TMI_908-GW(2)-01

Issue Identifier	Age IR	Age	Age Group / Order	Reference to Information Request	
TMI_908-GW(2)-01	GW(2)-01	1	CEA Agency	Reference to EIS Guidelines:	Part 2, Sections 9.1.1 and 9.1.2
				Reference to EIS / Appendix	n/a
				Cross-reference to Round 1 IRs	TMI_72-GW(1)-09, TMI_74-GW(1)-11, TMI_75-GW(1)-12, TMI_83-GW(1)-20, TMI_115-SW(1)-29
				<p>Identified Risks</p> <p>The groundwater model has a number of deficiencies, listed below, which raise uncertainties with the modelling exercise, the outputs of the model, and the effects assessments that incorporate those model outputs. These concerns are also tied with concerns raised in other IRs related to characterization of geochemistry on the site (see CEAA 31, 24 to 26 and 33), cover options for TSF and WRSAs (see CEAA 9 to 11 and 30), and TSF base and liner (see CEAA 14 and 29).</p> <ol style="list-style-type: none"> 1) Recharge rate uncertainty Recharge was based on very limited field observations which were conducted during unusually dry years (Appendix M of the revised EIS, Section 3.2 and Figure 9). Recharge rates have important implications for modelling the quantity of seepage. 2) Recharge rate uncertainty (WRA)

TMI_951-GW(2)-01B_ Figure 2
Thickness of Clay

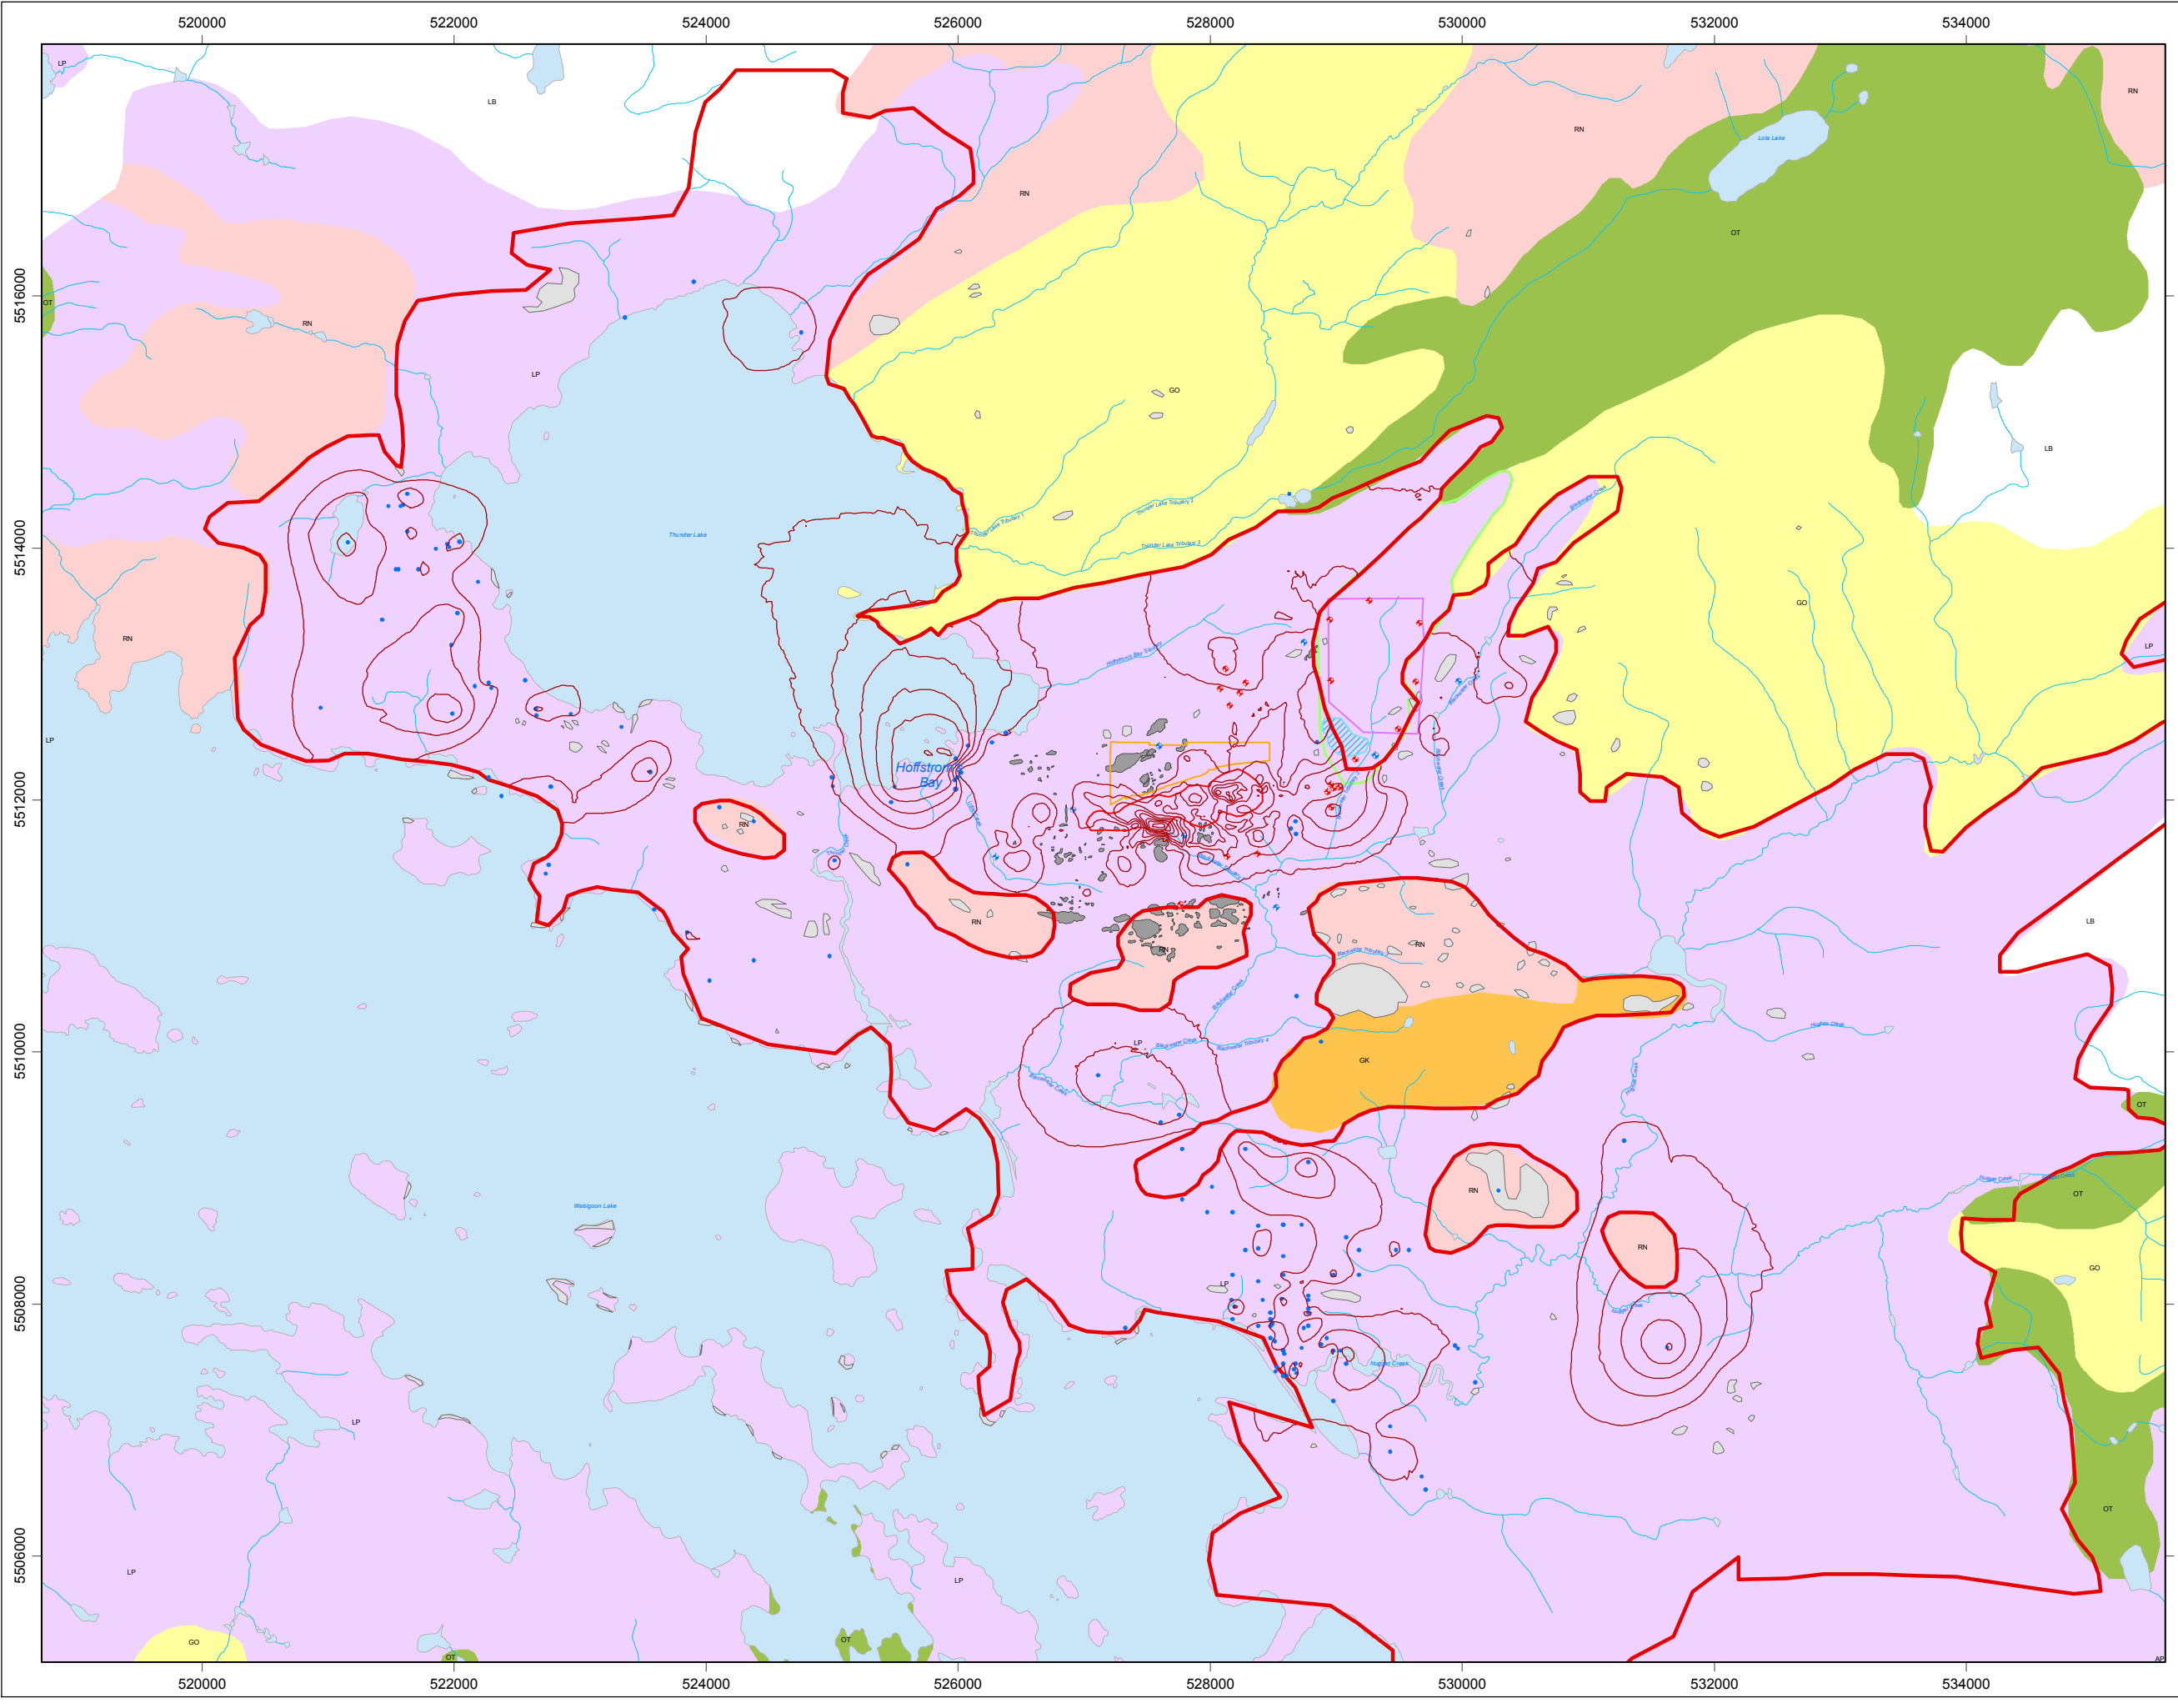
Issue Identifier	Age IR	Age	Age Groundwater Order	Requester's Information Request Response
				<p><u>Issue Identifier</u></p> <p>A. Provide an updated groundwater model that addresses all seven of the concerns raised in the “Context and Rationale” for this IR. Incorporate the findings from the IRs # MW(2)-08 and GW(2)-02 to GW(2)-04 in the revision of the model.</p> <p>B. Provide the potential range in seepage volumes (e.g. based on sensitivity analyses) from the TSF and WRSA. Also provide travel times for this seepage to various receptor locations. Include in this assessment, an explanation of how seepage volumes would be expected to flow through various geologic layers.</p> <p>C. Determine the capture efficiency of the seepage collection system, and assess the efficiency based on different ditch depths, and whether efficiency can be improved through the use of additional mitigation measures such as pump-back wells.</p> <p>D. Reassess the changes in water quality from seepage emanating from the TSF and WRSA and an updated groundwater model, taking the responses from Questions A to C into consideration.</p> <p>E. Revise the effects to fish and fish habitat and Indigenous health from impacted private groundwater wells taking the response from Question D into consideration.</p> <p>F. Describe additional mitigation measures to prevent adverse effects to fish and fish habitat and Indigenous health from impacted private groundwater wells, if necessary, taking into consideration the response to Question E.</p> <p>G. Characterize residual effects, if any, after the mitigation measures described in Question F have been implemented.</p> <p>H. Update the follow-up program for potential effects to fish and fish habitat and Indigenous health from impacted private groundwater wells, including objectives and any monitoring measures that will be implemented to verify the predictions of effects and evaluate the effectiveness of the proposed mitigation measures. If follow-up is not required, provide a rationale.</p> <p>I. Incorporate the findings from this IR into the revision of seepage water quality assessment requested in IR# MW(2)-06.</p> <p>THIS IR SUPERSEDES IR# GW(2)-01.</p> <p><u>Response</u></p> <p><u>Part A:</u></p> <p>Treasury Metals had undertaken a review of the inputs, assumptions and outputs of the groundwater model in response to the seven concerns raised in the “Context and Rationale”. As detailed below, the review did not identify deficiencies in the assumptions and inputs that would warrant updating the groundwater model. The groundwater model used for the Goliath Gold Project was used to characterize the transport of seepage from the WRSA and TSF, as well as the rate of inflow into the open pit and underground mine workings. Detailed justification for retaining the</p>

Issue Identifier	Age IR	Age	Age Groundwater Order	Request Reference Information Request Response
				<p>Goliath Gold open pit, and the Victor kimberlite deposit is situated in several karstic dolostone formations. The groundwater pumping rates for the Victor Diamond open pit are two order of magnitudes greater than predicted for the Goliath Gold open pit.</p> <p>Therefore, it would not be reasonable to expect the Goliath Gold Project to collect as many of hydrogeological/geotechnical measurements as were collected for the Detour Gold, Rainy River Gold or Victor Diamond mining projects.</p> <p>Regarding the information in Table 5.6.2.2-1 of the revised EIS (April 2018), these data are almost all correct and are the same as given in the AQTESOLVE analysis sheets provided in Appendix C of Appendix M of the revised EIS (April 2018) with the geological data corresponding to the borehole logs of Appendix C of Appendix M of the revised EIS (April 2018).</p> <p>The exception is for Well 5A where the hydraulic conductivity should have been rounded to 1.1×10^{-6} m/s rather than 1.0×10^{-6} m/s. The geometric mean and arithmetic mean should be 9.1×10^{-7} m/s and 9.6×10^{-7} m/s rather than 9.2×10^{-7} m/s and 9.8×10^{-7} m/s, respectively. These typos concerning the means also occur in Section 4.1 of Appendix M of the revised EIS (April 2018). The hydraulic conductivity values are largely representative of silty sands that occur at the base of the overburden and are consistent with published literature (e.g., Freeze and Cherry, 1979). There is one anomalous value (Well 5A), which gave a value of 1.1×10^{-6} m/s, untypical for the screened unit of clay, as noted in Section 4.1 of Appendix M of the revised EIS (April 2018). The log for Well 5A (Appendix A of Appendix M of the revised EIS [April 2018]) shows three split spoons across the screened interval, which all indicate clay. It is possible that the higher than normal hydraulic conductivity may be due to a thin sand or gravel seam occurring between the split spoon samples not being recognized during drilling of the borehole.</p> <p>4. Thickness of the Overburden</p> <p>The upper three (3) layers of the groundwater model correspond to:</p> <ul style="list-style-type: none"> Model Layer 1 is the surface layer and corresponds to the Clay, Sand and Gravel, the upper layer of the Sand-Clay/Silt Sand unit or bedrock knoll, depending on the surficial geology. Model layer 2 corresponds to the Basal Sand unit in the areas where it is expected to be thicker than 0.3 m. The basal band layer is discontinuous layer at the base of the clay, that is, on average, 3 to 4 m thick, when present. Model layer 3 corresponds to the weathered Shallow Bedrock unit, which was assumed to have a uniform thickness of 7 m. It is widely recognized that the shallow weathered and fractured bedrock tends to be the more permeable than the deeper bedrock in a shield crystalline bedrock setting, such as occurs at the Goliath Gold Project. <p>The thickness of the overburden, basal sands vary over the modelling domain based on the available data. TMI_951-GW(2)-01B_Figure_1, TMI_951-GW(2)-01B_Figure_2, and TMI_951-GW(2)-01B_Figure_1 show the thickness maps for the Basal Sands (Model Layer 2), Clay (Model Layer 1) and Sand and Gravel (Model Layer 1 and</p>

Issue Identifier	Age IR	Area	Age Groundwater	Request Reference
				<p>2) respectively. For each of the maps, surface water bodies, private wells and monitoring wells, as well as the mining facilities are shown. Bedrock sits beneath the Basal Sand, Clay, and Sand and Gravel layers, with the upper 7 m identified as weathered and fractured shallow bedrock.</p> <p><u>5. Porosity estimates</u></p> <p>To clarify, 0.01 (or 1%) was used as the kinematic porosity for the shallow bedrock, not the total porosity. When trying to understand the travel times for seepage in bedrock, the parameter of greatest importance is the kinematic porosity (or effective porosity). The kinematic porosity, which describes the ability of a fluid to travel through a media, is always lower than the porosity. Kinematic porosities for weathered bedrock provided in literature (Worthington, Smart and Ruland, 2012), suggests that values in the range of 0.01%–0.1% are possible carbonate aquifers, but posits a value of 1% is possible. The kinematic porosity of 0.01 used for the groundwater velocity calculation (memo to Mark Wheeler, Treasury Metals; “Additional Hydrogeological Information”, dated March 29, 2018, as appended to Appendix M) represents the porosity of open, weathered fractures at the bedrock surface. The Basal Sand at the base of the overburden is discontinuous as noted in the memo referred to above. Nevertheless, as fractures in the shallow bedrock will also be discontinuous, it is correct that flowpaths</p> <p><u>6. Particle Tracking</u></p> <p>Particle tracking has been undertaken with the groundwater model representing the ultimate dewatered mine condition with particles released from the TSF. As described in the response to TMI_911-GW(2)-04, the particle tracking plots for TSF during operations (TMI_911-GW(2)-04_Figure_1) show that, of the seepage leaving the TSF, 46% is captured by the open pit; 34% is captured by the TSF perimeter drains; 14% is captured by the minewater pond, and 6% escapes the operations area and reports to Blackwater Creek. The proportion that escapes the operations area to report to Blackwater Creek occurs along the eastern perimeter of the TSF. The particle tracking for the WRSA during operations (see TMI_911-GW(2)-04_Figure_2) indicates that all water seeping from the base of the uncapped WRSA during operations is captured by the open pit.</p> <p><u>7. Sensitivity Analyses</u></p> <p>Sensitivity analyses have already been undertaken with the groundwater model for the shallow bedrock and basal sand as shown in Table 9 of Appendix M to the revised EIS (April 2018). The focus of this sensitivity analysis was on the identification of seepage volumes into the open pit and underground mine workings, instead of the effects on the rates of seepage from the WRSA. As detailed in the responses to TMI_909-GW(2)-02 and TMI_911-GW(2)-04, all of seepage from the uncapped WRSA during operations and closure will be captured by the open pit, and will not reach the receiving environment. The uncapped WRSA scenario will only exist during operations and for a short period of time during closure when a low-permeability dry cover will be constructed over the WRSRA as described in Section 3.16.8. The multi-layer, low permeability dry cover over the WRSRA is intended to reduce the rate of infiltration into the</p>
